Appendix X: Public Comments Received with DOH-CAB Responses and Final Permit Amendments August 12, 2022 RH-SIP Submittal 2024 RH-SIP, Revision 1 Submittal

Comments on Regional Haze Rule Modeling from Maui Electric Company, Ltd. Hawai'i Electric Light Company, Inc. Received on April 12, 2022

Subject: Comments on Regional Haze Rule Modeling Hawai'i Electric Light Company, Inc. Maui Electric Company, Ltd.

Figure 3.1-2 Progress for Baseline, Current, and Natural Visibility Conditions at Hawaii Volcanoes NP for Clearest and Most Impaired Days

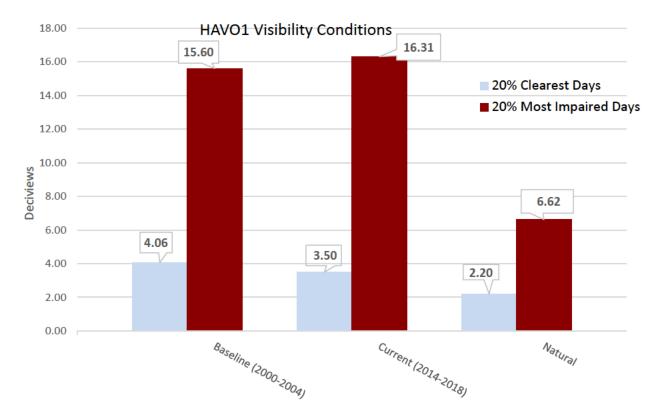
In some locations in the text of the draft SIP, the name of Hawai'i Volcanoes National Park is incorrectly given as "Volcanoes National Park." These locations include the list of figures (for Figure 1.3–2), in Table 1.2–1 page 3, and in the title of Figure 1.3–2 on page 5. Please correct these with the full park name "Hawai'i Volcanoes National Park."
